**Subject: Final Feasibility Study for the Munitions Washout Facility (SEAD-4),  
Seneca Army Depot Activity**

**Subject: Final Feasibility Study for the Munitions Washout Facility (SEAD-4),  
Seneca Army Depot Activity  
EPA Site ID: NY0213820830 - NY Site ID: 8-50-006;**

**FINAL  
FEASIBILITY STUDY  
AT THE MUNITIONS WASHOUT FACILITY (SEAD-4)**

FIGURE 2-10  
 CASE 3 REMEDIAL ACTION OBJECTIVE  
 SURFACE SOIL

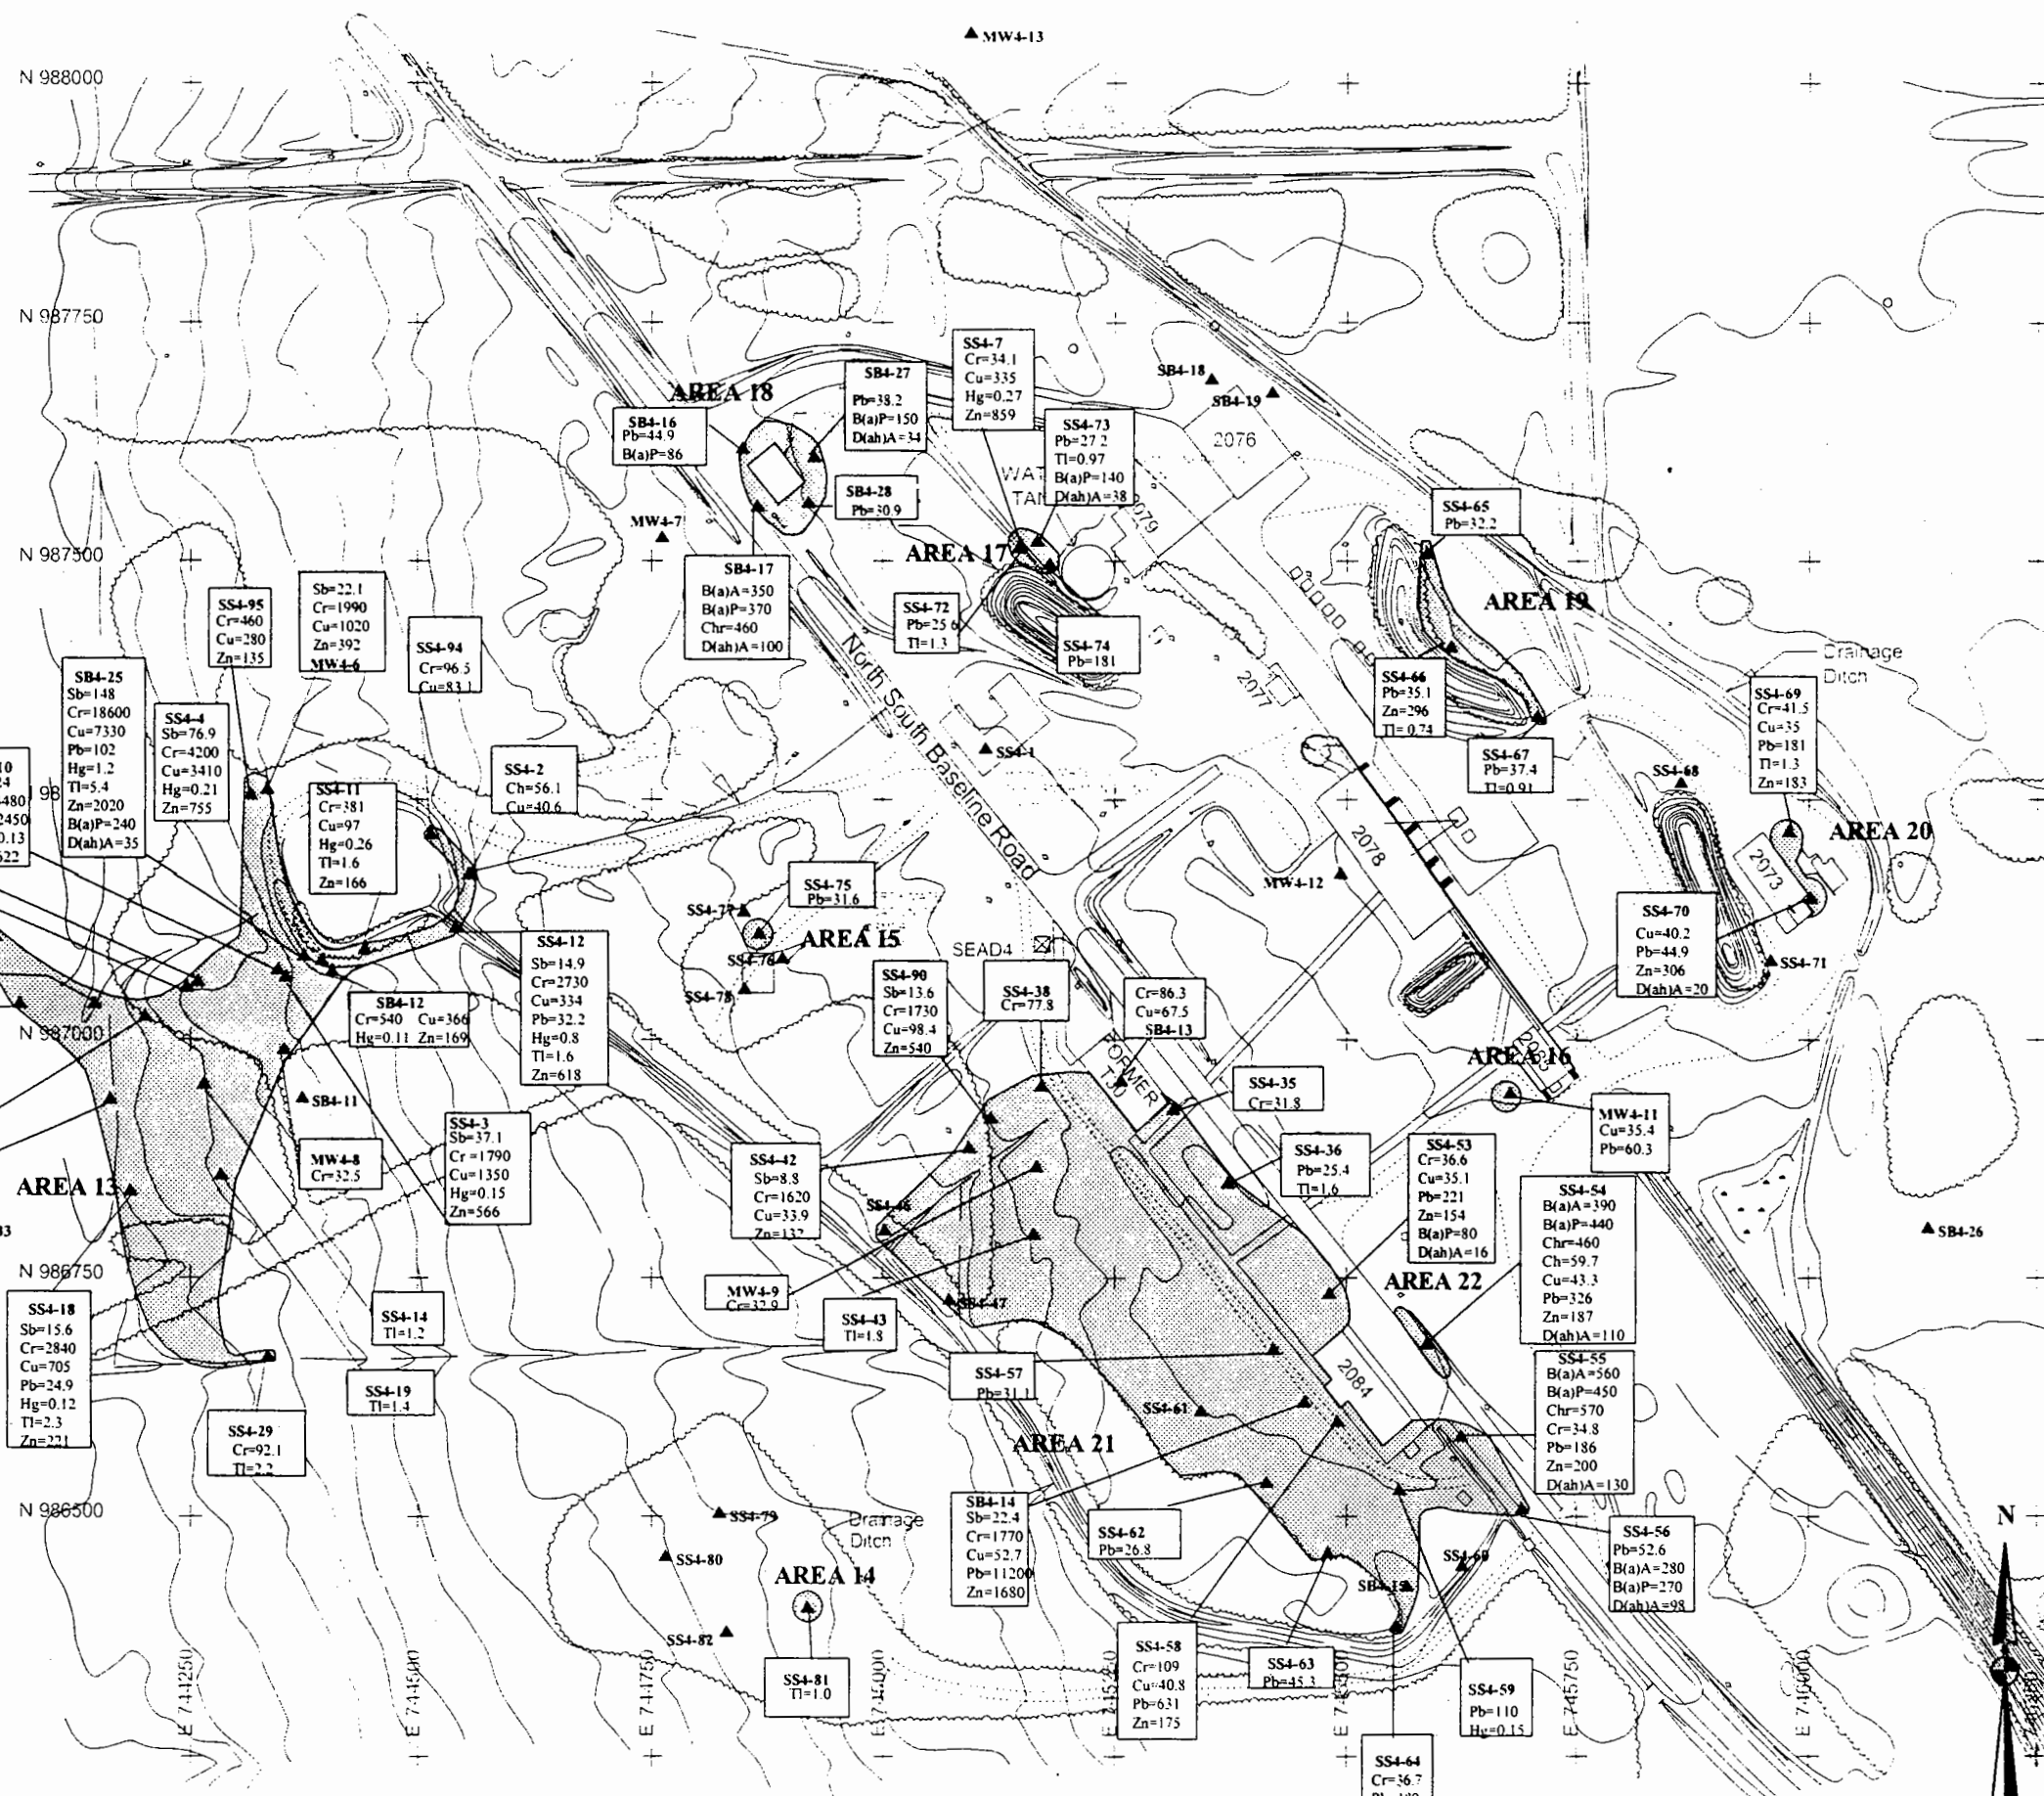
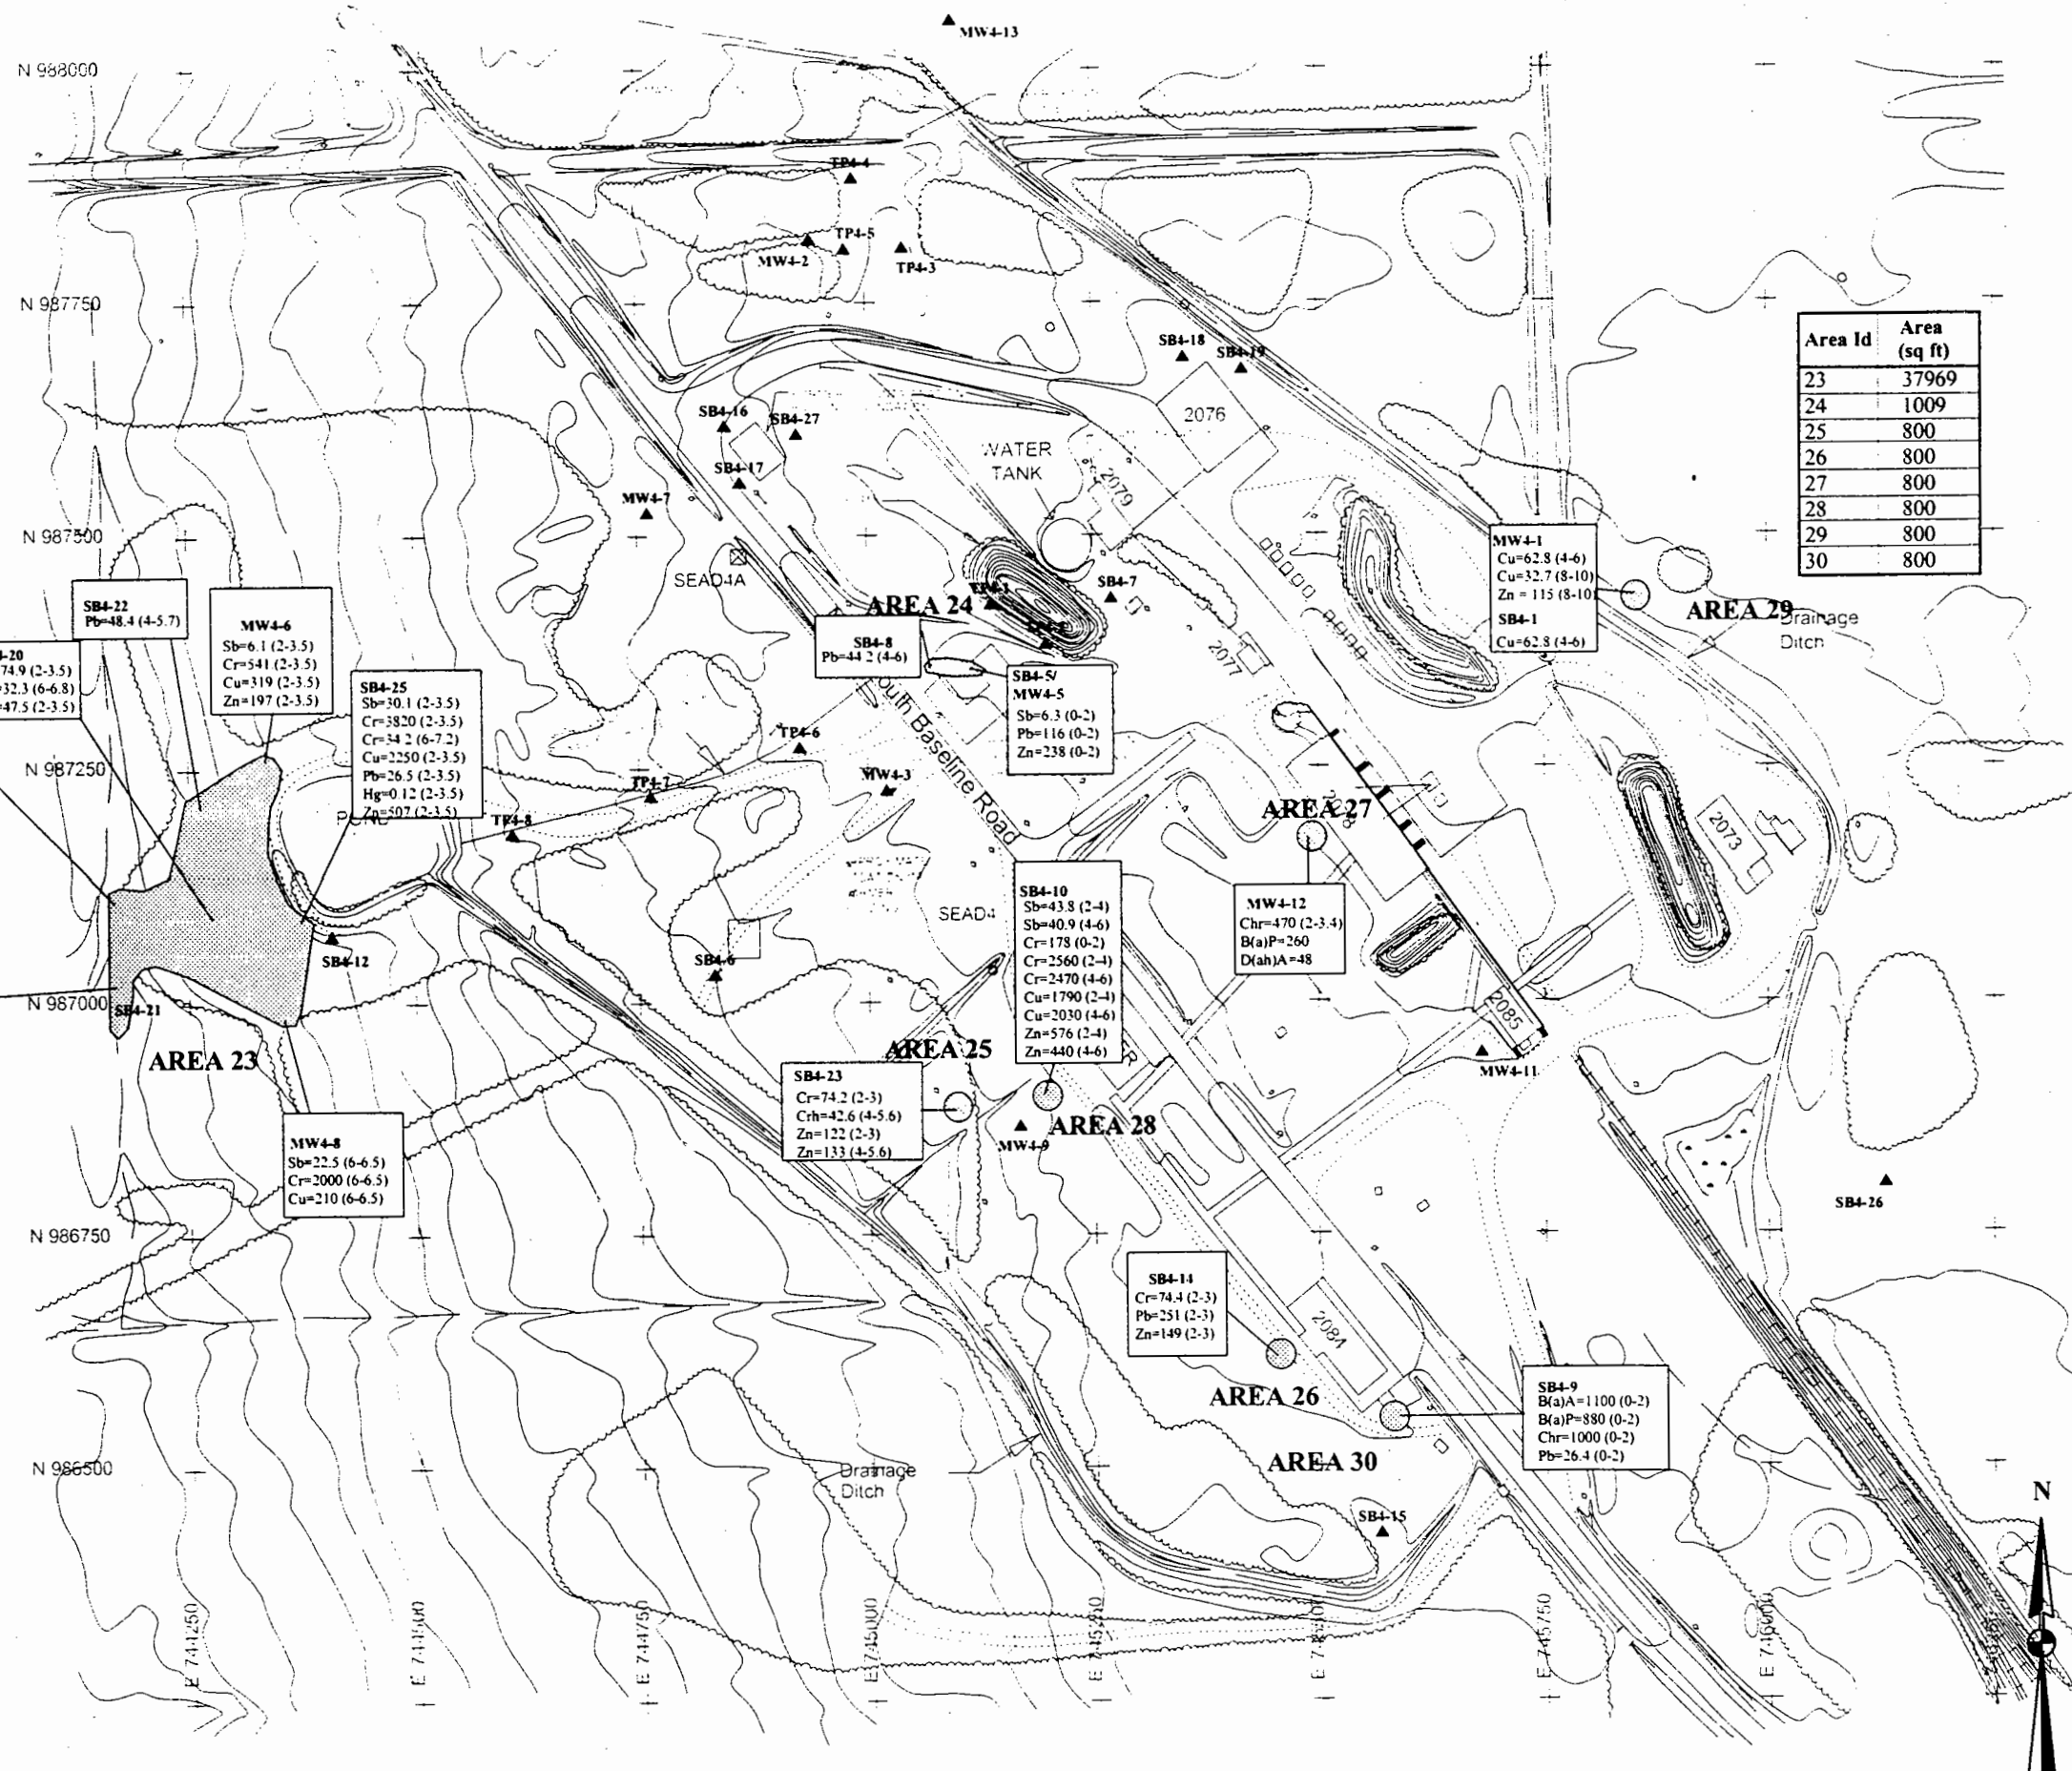
**Comment 12:** Figures 2-10 through 2-12: The tables in the legend of each figure are difficult to read. Please make them legible.
